SITE CHARACTERIZATION REPORT - HYDROLOGIC CHARACTERIZATION

**HYDE PARK LANDFILL SITE
TOWN OF NIAGARA, NEW YORK**

APPENDIX C - RESPONSES TO AGENCY COMMENTS

**Prepared For:
Miller Springs Remediation Management, Inc.**

figure 3-18
TRANSMISSIVITY DISTRIBUTION IN FZ-08
SITE CHARACTERIZATION REPORT
HYDE PARK LANDFILL SITE
Town of Niagara, New York

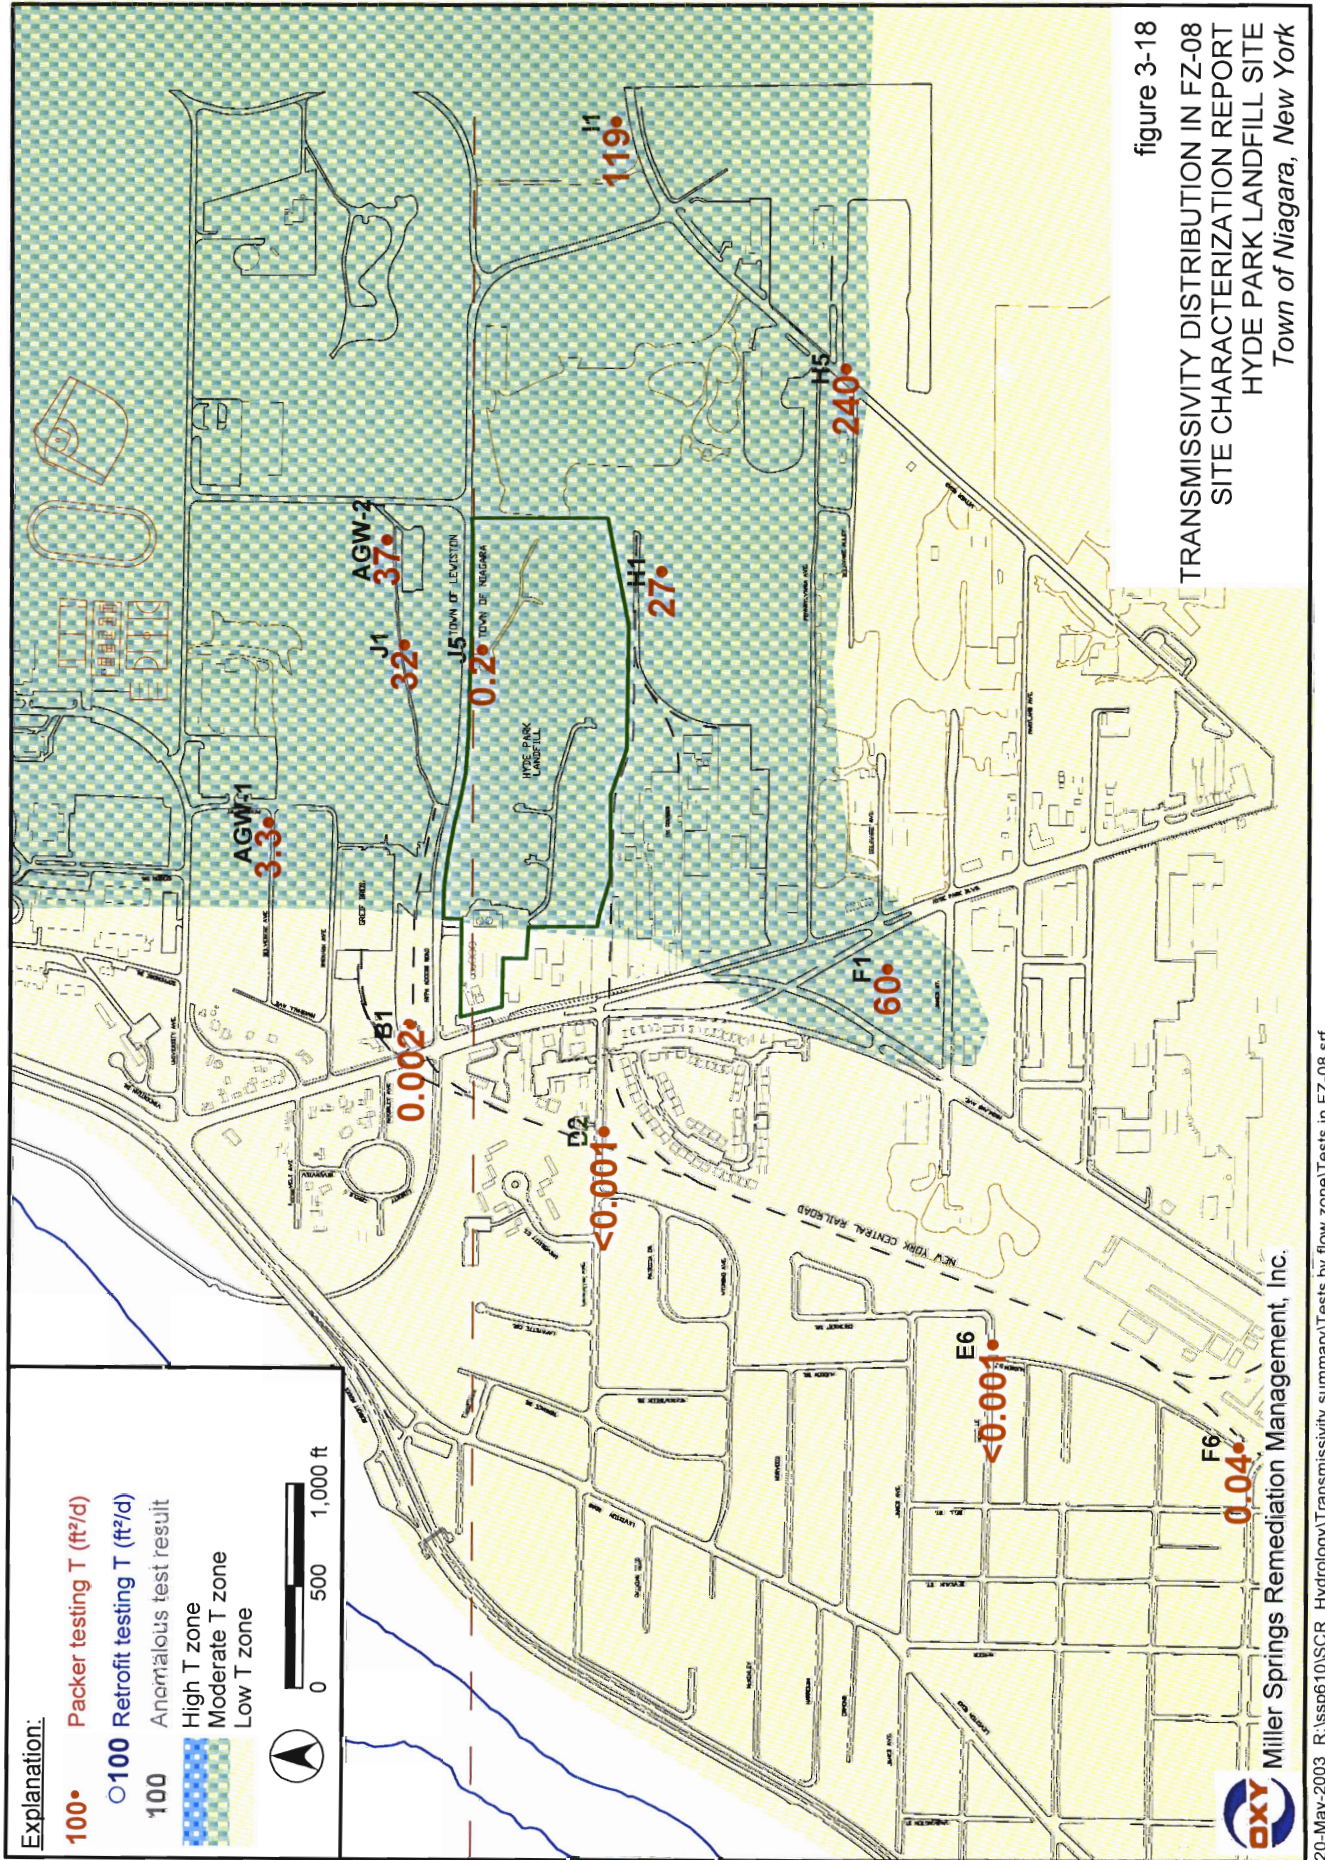
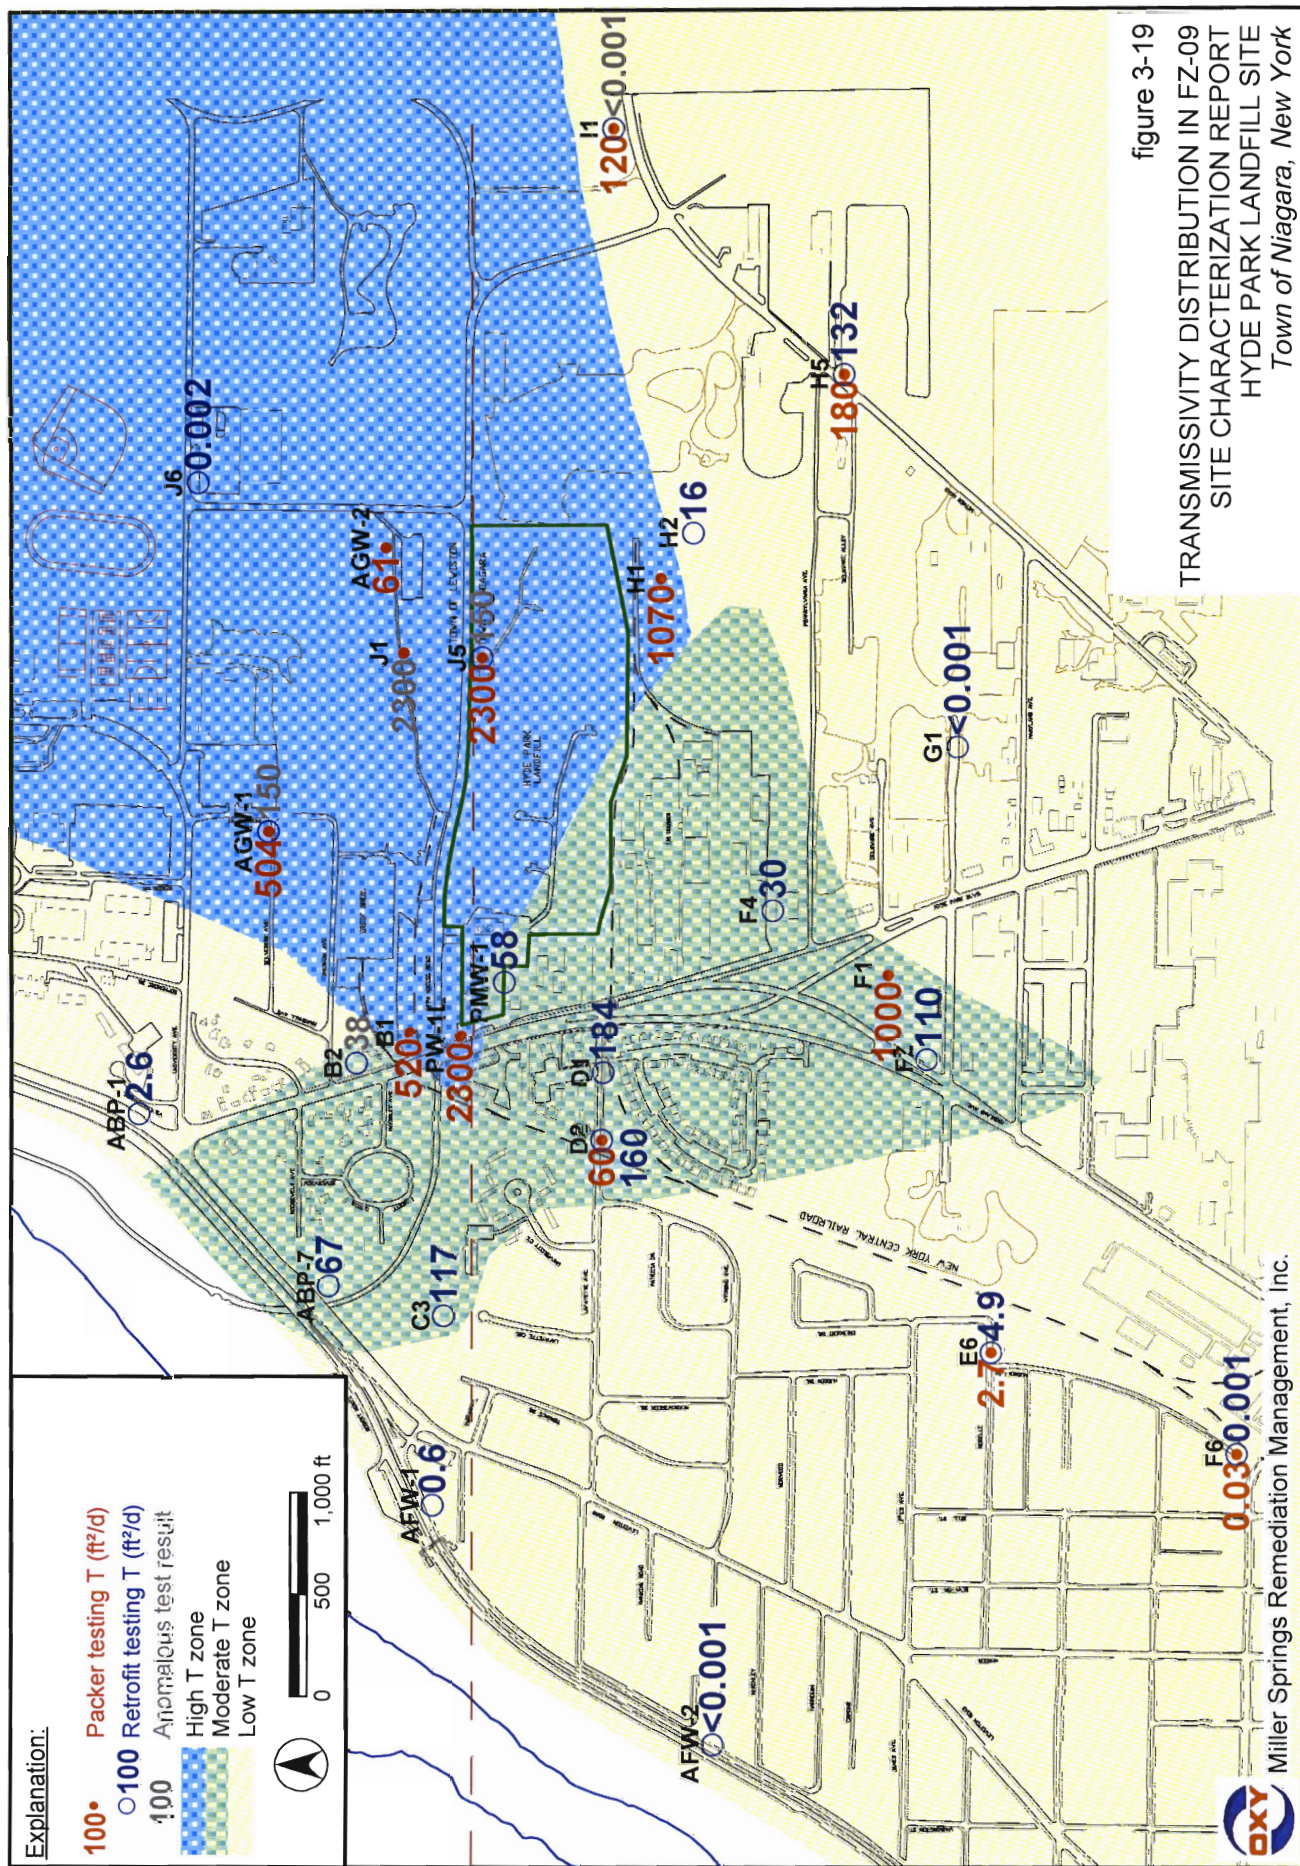
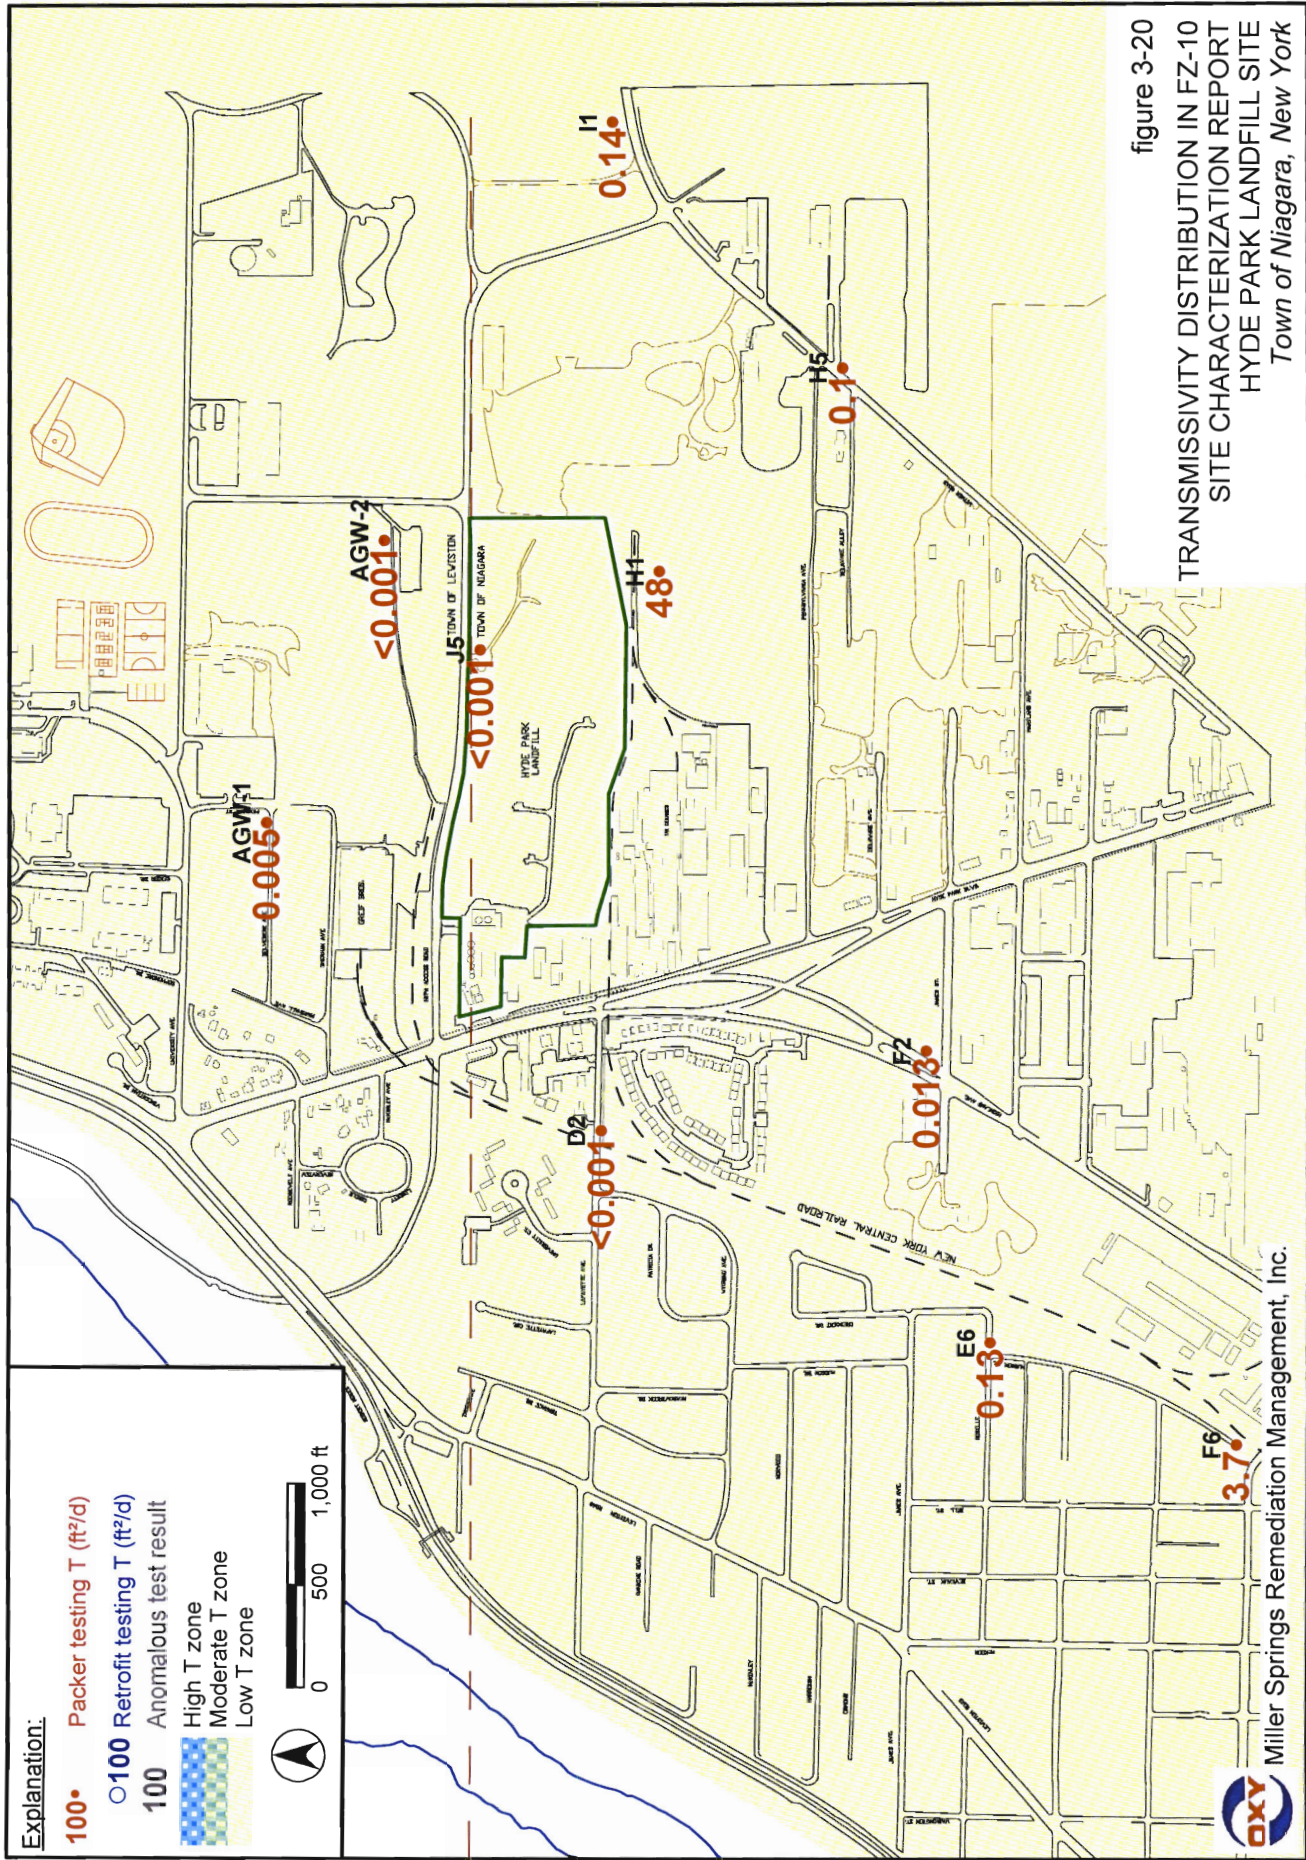
52. Figures 3-11 through 3-21. General comment: various transmissivity values are incorrect in comparison with the values presented in Appendix A. Please check values and edit.

The problem with Figure 3-12 was identified in our review of the final document. We apologize for the errors. All tables and figures have been checked. In some cases, the values indicated on the figures have been modified slightly to be absolutely consistent with the values provided in the tables. We are submitting a revised set of transmissivity maps, Figures 3-13 to 3-21, with these responses.

See the response to Comment S1.
